Work Session: City Hall Update

Eugene City Hall – Phase 1

Summary of Initial Cost Reduction Strategies for City Hall

2016-09-01
COST REDUCTION
STRATEGIES

DOUBLE SKIN DIAGRAM

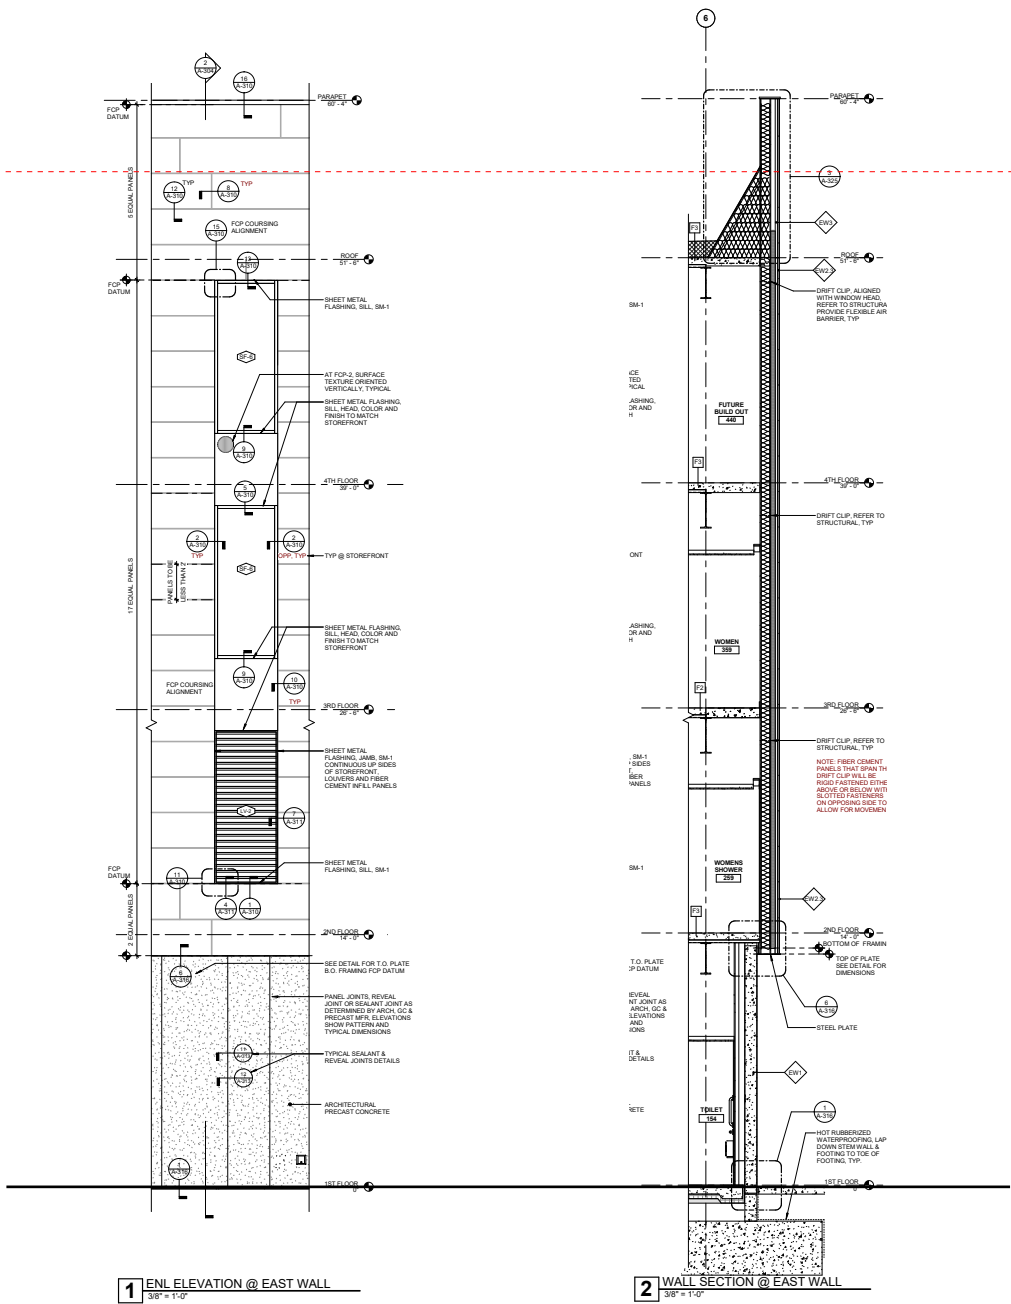
The removal of the outer glass curtain wall and associated structure on the south façade is likely to be the most significant opportunity for cost reduction, as it eliminates a substantial area of

Removing the glass curtain wall from the south façade would also likely lead to the elimination or simplification of several other components, including: structural steel supports, sunshade/catwalks, mechanical dampers for passive ventilation, roof canopy, roof parapets, entry canopies, access ladders, fire protection measures, and automated windows. This design change could also lead to reductions in parapet height, cladding area, and revisions to the roof structure and rooftop photovoltaic structure that could generate meaningful savings. With the removal of double-skin façade's outer wall, the SSG curtain wall on the north façade would also be revised to a standard curtain wall.

Diagram: Reduce project scope and program while retaining Civic Quality of Site

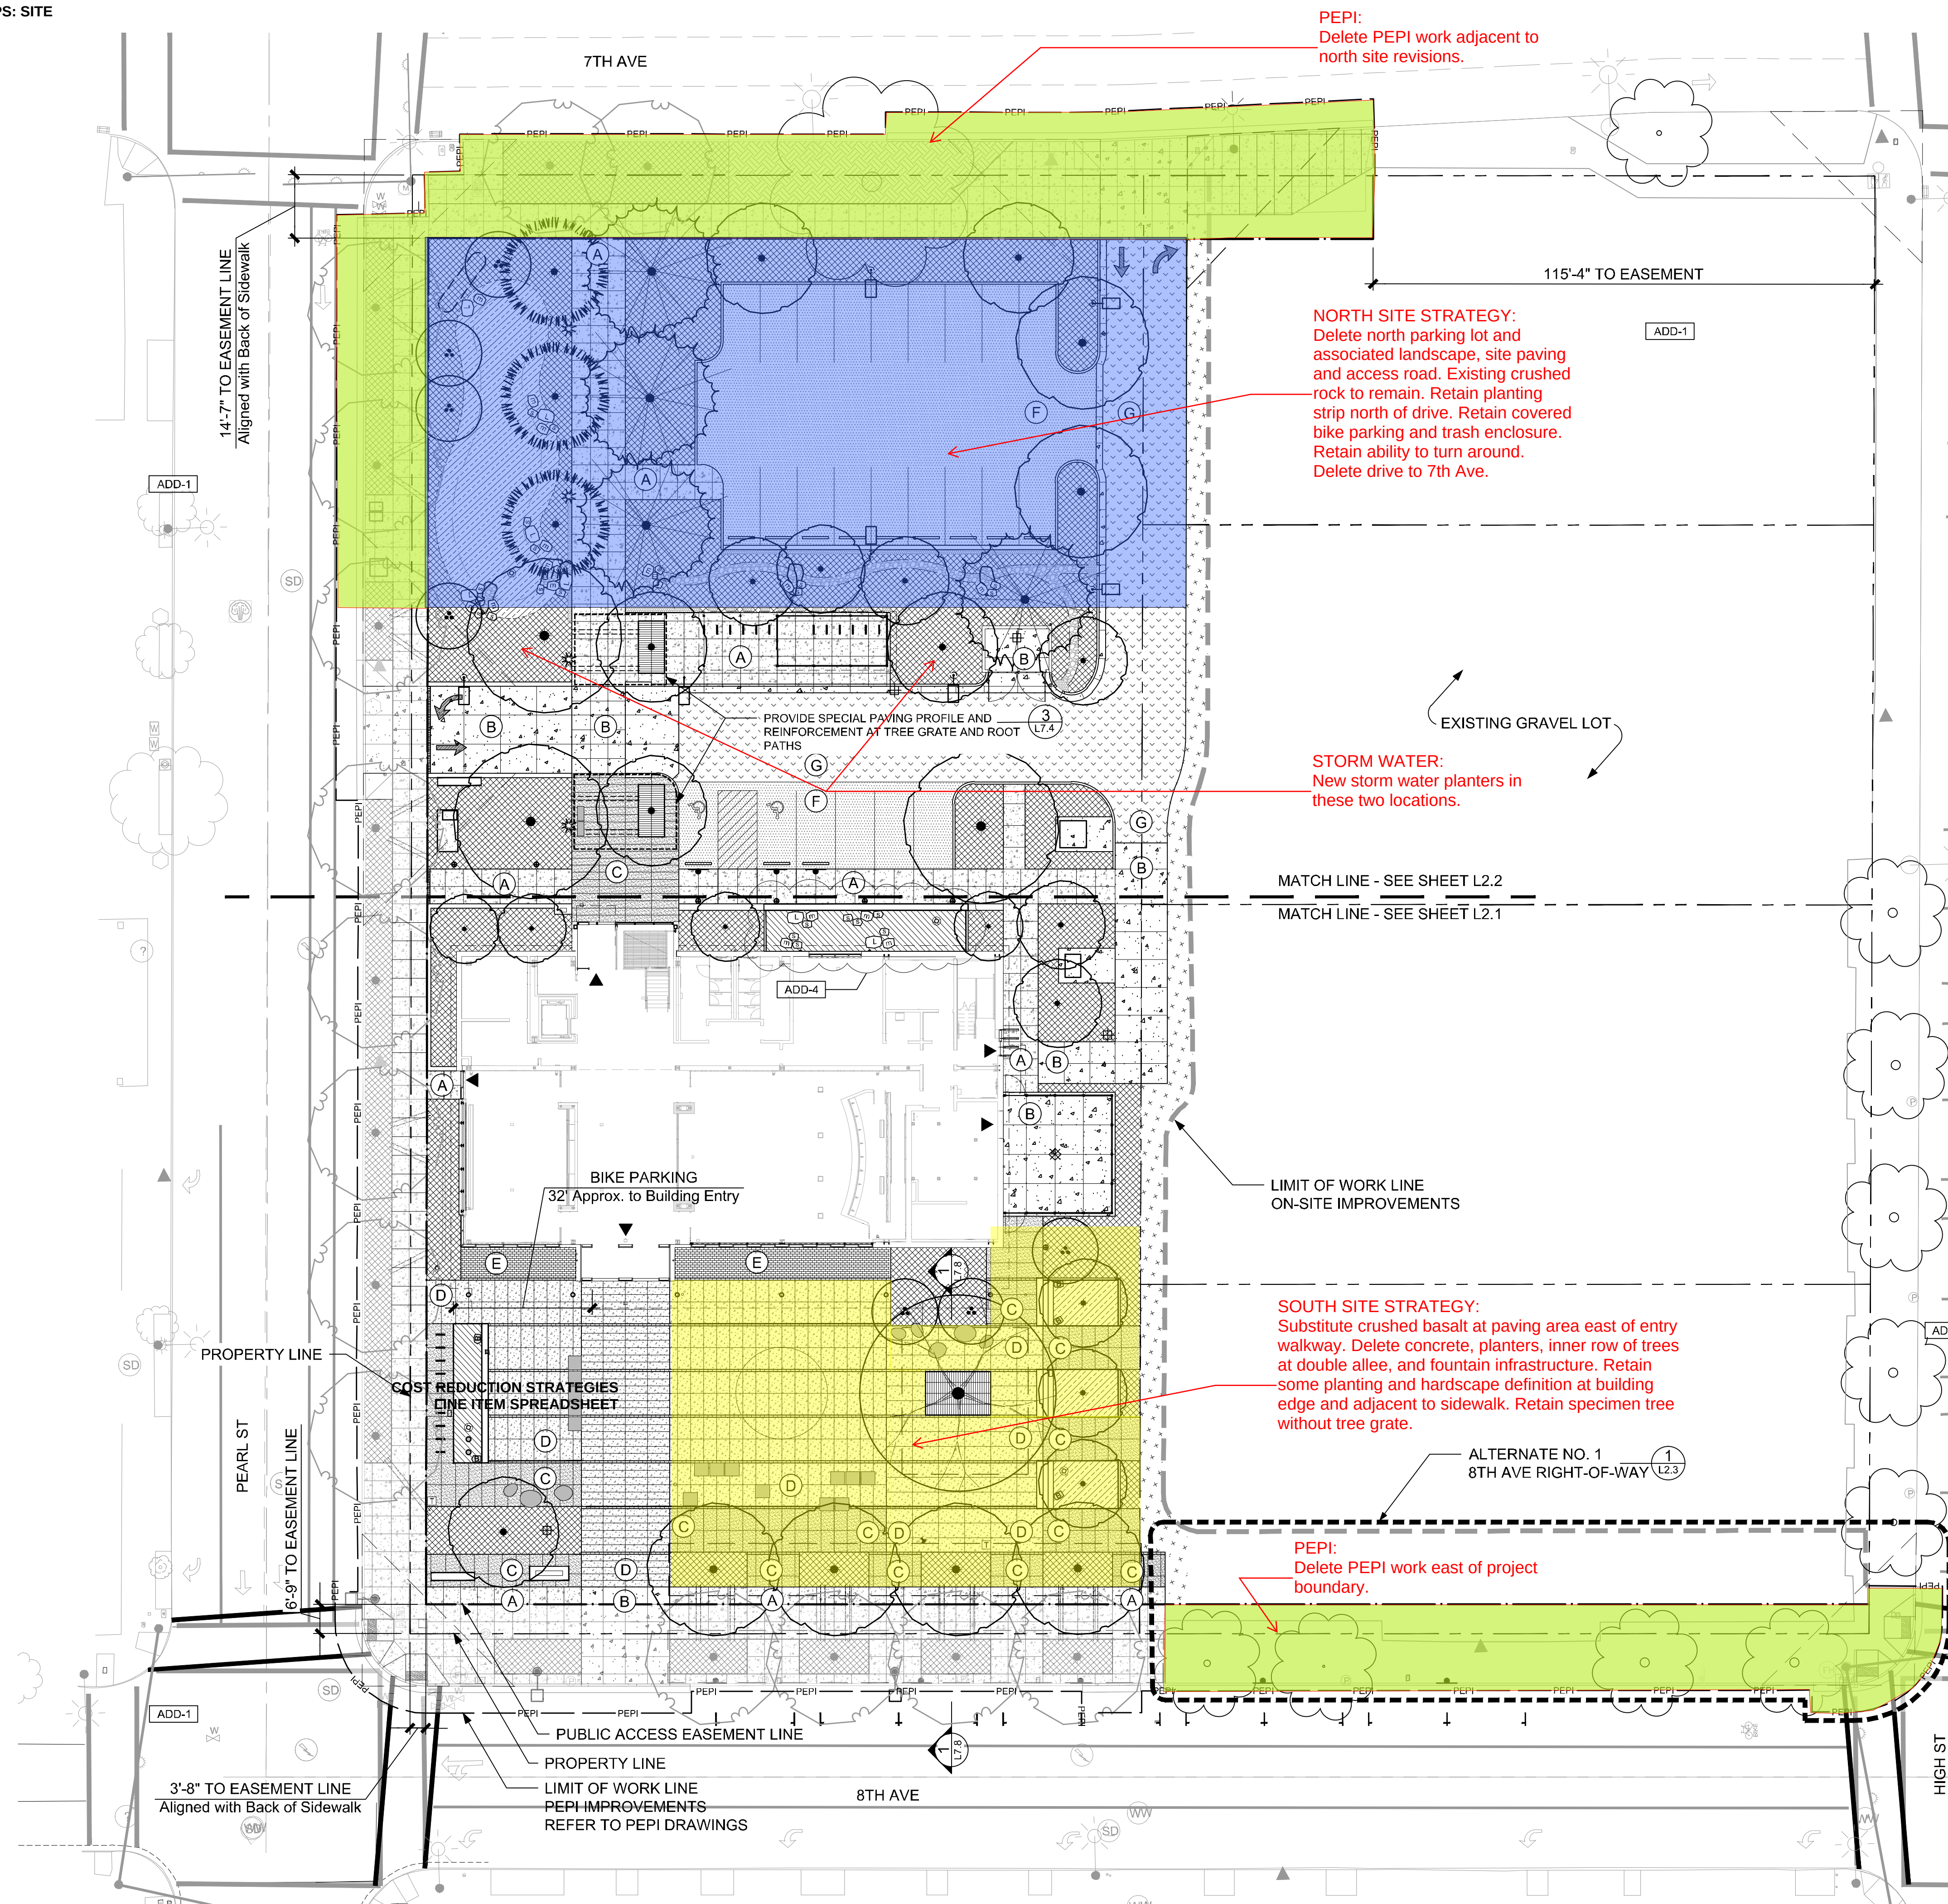
- 1. NORTH SITE STRATEGY:**
Delete north parking lot and associated landscape, site paving and access road. Existing crushed rock to remain. Retain planting strip north of drive. Retain covered bike parking and trash enclosure. Retain ability to turn around. Delete drive to 7th Ave.
- 2. SOUTH SITE STRATEGY:**
Substitute crushed basalt at paving area east of entry walkway. Delete concrete, planters, inner row of trees at double alley, and fountain infrastructure. Retain some planting and hardscape definition at building edge and adjacent to sidewalk. Retain specimen tree without tree grate.
- 3. PEPI:**
Delete PEPI work adjacent to north site revisions. Delete PEPI work east of project boundary.

COST REDUCTION STRATEGY 2:
Reduce Civic Quality of Site but retain overall program and scope.

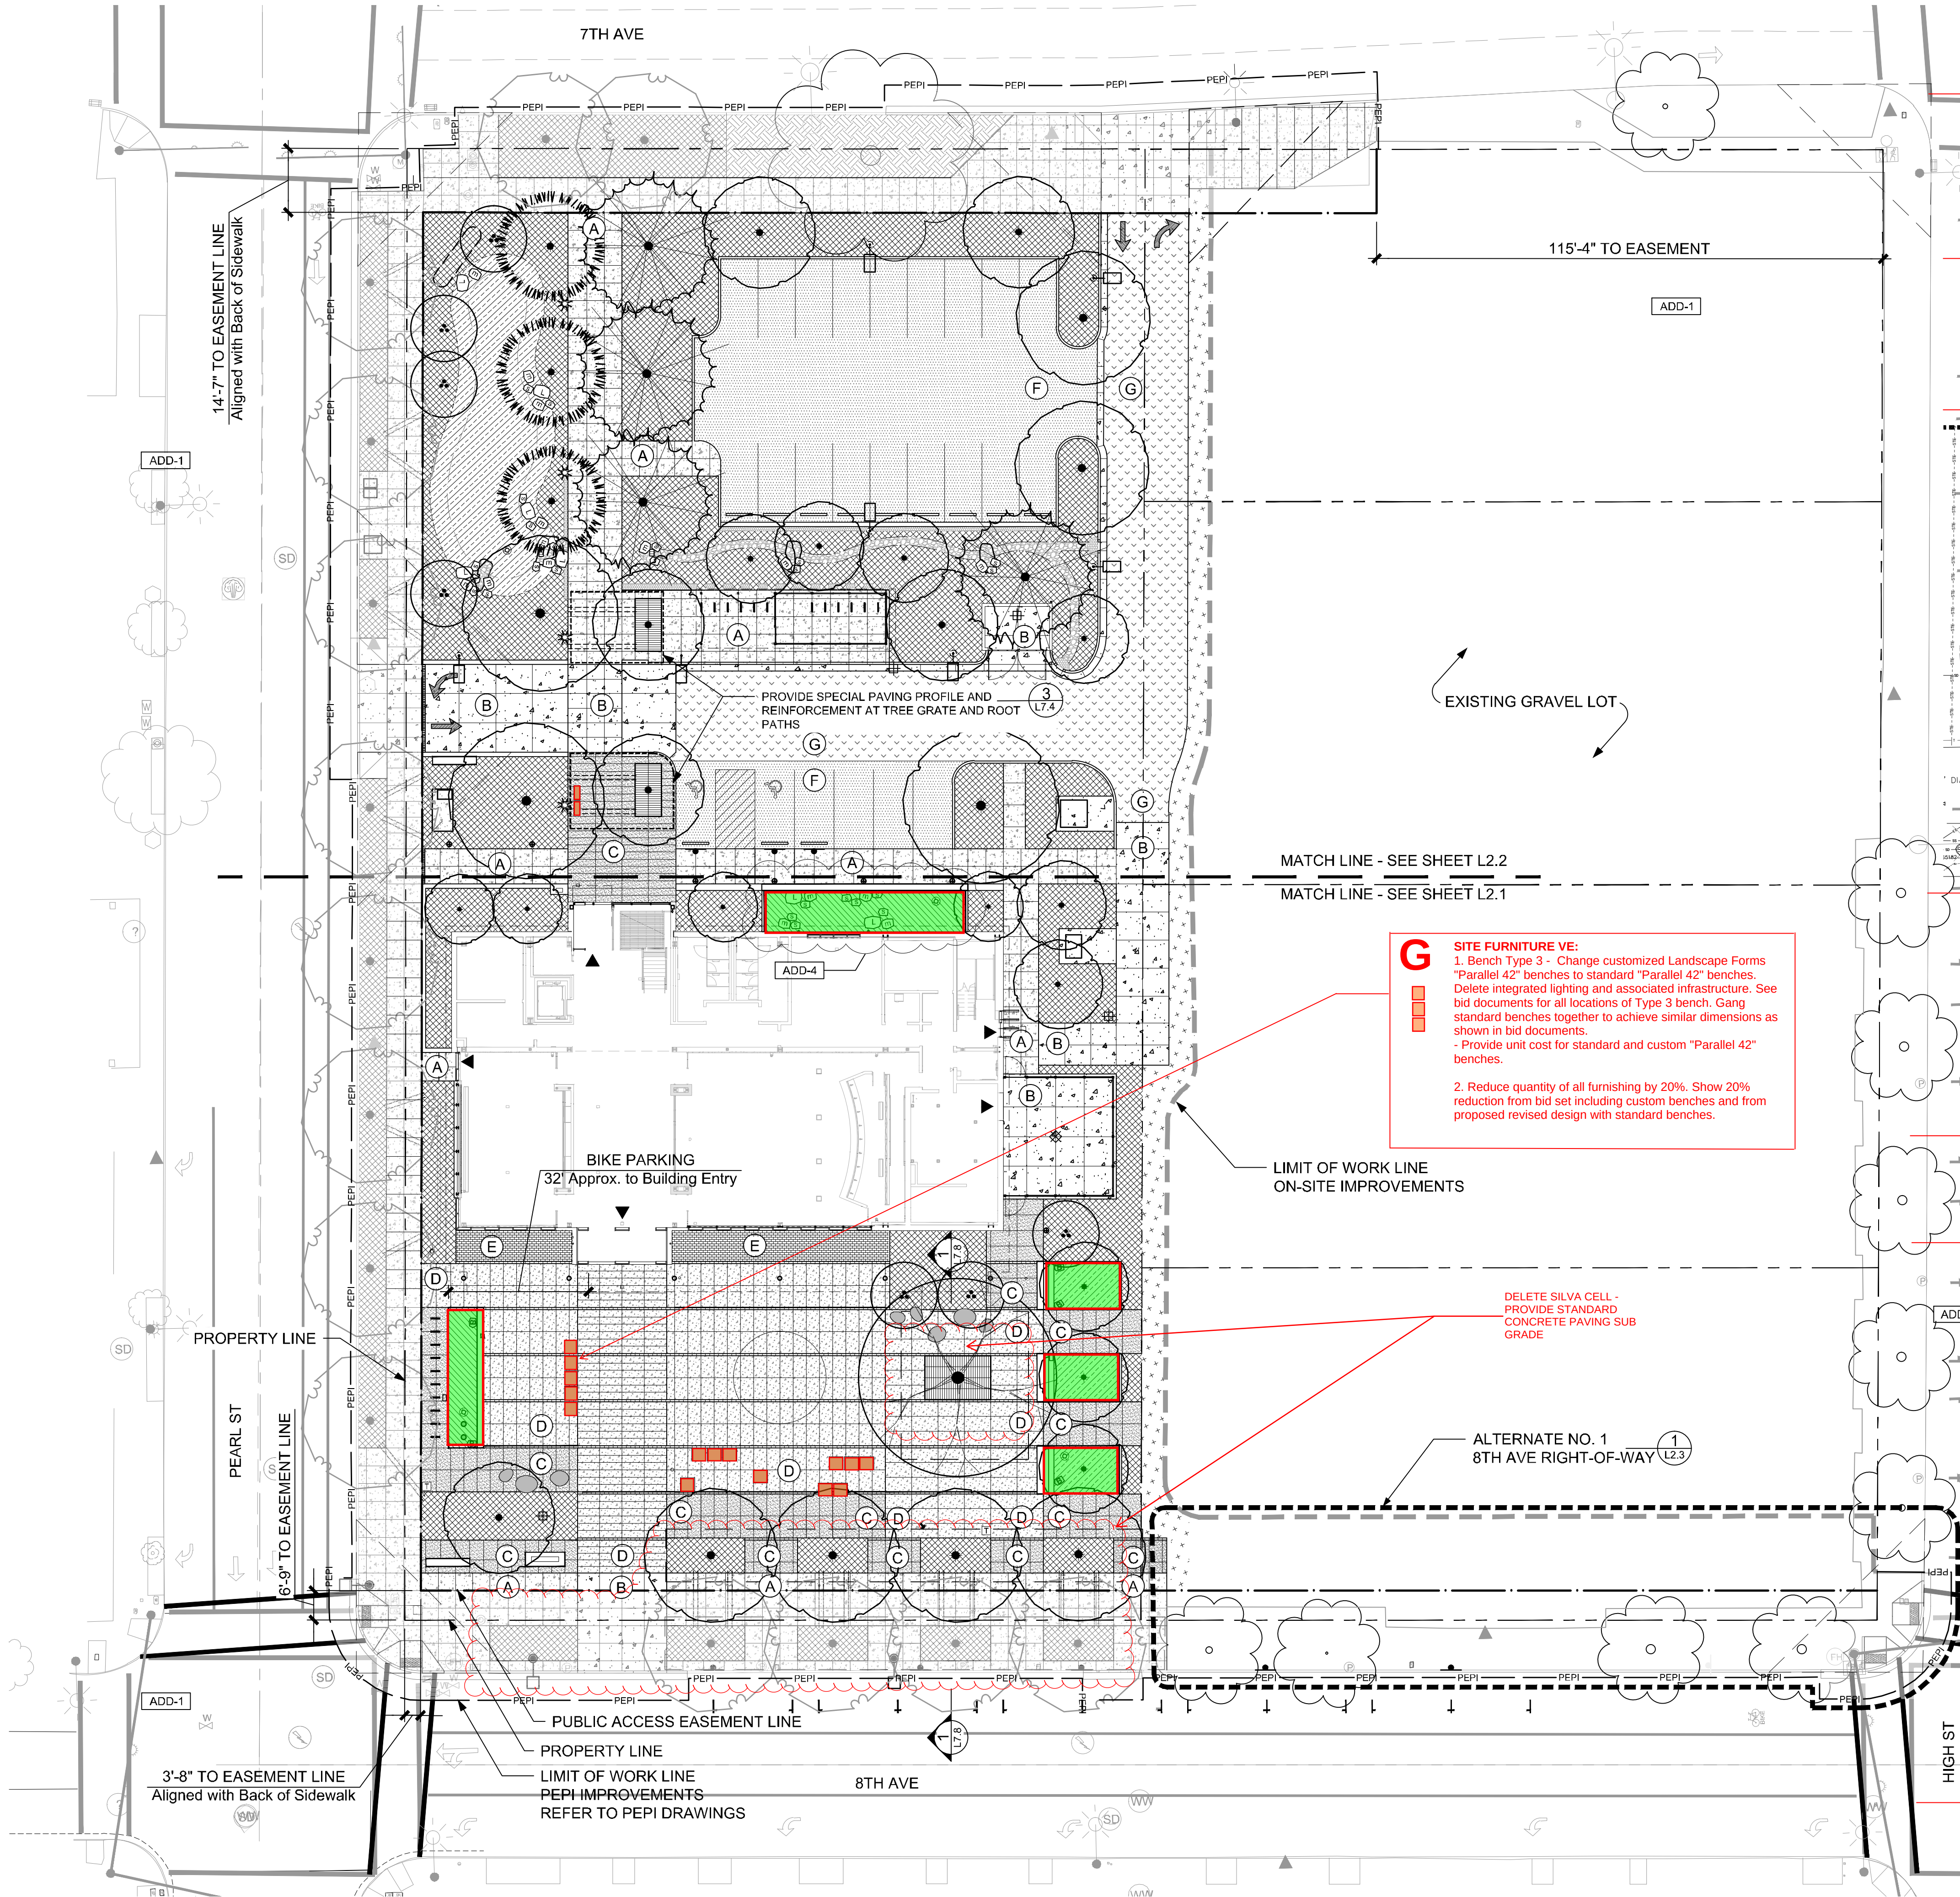
A Soil VE
Soil: provide primary planting soil in all planting areas to 18" depth. Below 18" or outside of planting area, any local loam is acceptable.

B Planting VE
Reduce density of planting by 20% (excluding trees) while still meeting code.

C WATER FEATURE VE
Delete future water feature infrastructure:
- backflow
- vaults
- power
- conduit/piping
- grading changes, trench drain

D SILVA CELL VE:
Eliminate Silva Cells:
In ROW - Delete all.
(PW has requested this in the permit review)
On Site - Delete at specimen tree and all other locations.

E STORM WATER PLANTER VE:
Delete weathering steel in plaza and roof runoff storm water planters.
Concrete retaining walls to remain as detailed.
Delete Lighting in planters.
Delete the steps / seating at east plaza planters
Provide concrete retaining wall as detailed.

F PLAZA PAVING VE ITEMS:
Provide line item cost for each of the 4 items below.

1. SIMPLIFY / REDUCE AMOUNT OF JOINTING IN THE PLAZA PAVING. DESIGN TBD. BUDGET FOR JOINTING REDUCTION OF 30%.

2. DELETE SAND WASH FINISH - PROVIDE LIGHT BROOM FINISH
DELETE CONCRETE COLOR - PROVIDE STANDARD CONCRETE 4" THICKNESS

3. DELETE SAND WASH FINISH - PROVIDE LIGHT BROOM FINISH
DELETE CONCRETE COLOR - PROVIDE STANDARD CONCRETE 7" THICKNESS

4. DELETE UNIT PAVING. PROVIDE CONCRETE PAVING TO MATCHING ADJACENT CONCRETE PAVING.

G SITE FURNITURE VE:
1. Bench Type 3 - Change customized Landscape Forms "Parallel 42" benches to standard "Parallel 42" benches. Delete integrated lighting and associated infrastructure. See bid documents for all locations of Type 3 bench. Gang standard benches together to achieve similar dimensions as shown in bid documents.
- Provide unit cost for standard and custom "Parallel 42" benches.
2. Reduce quantity of all furnishing by 20%. Show 20% reduction from bid set including custom benches and from proposed revised design with standard benches.
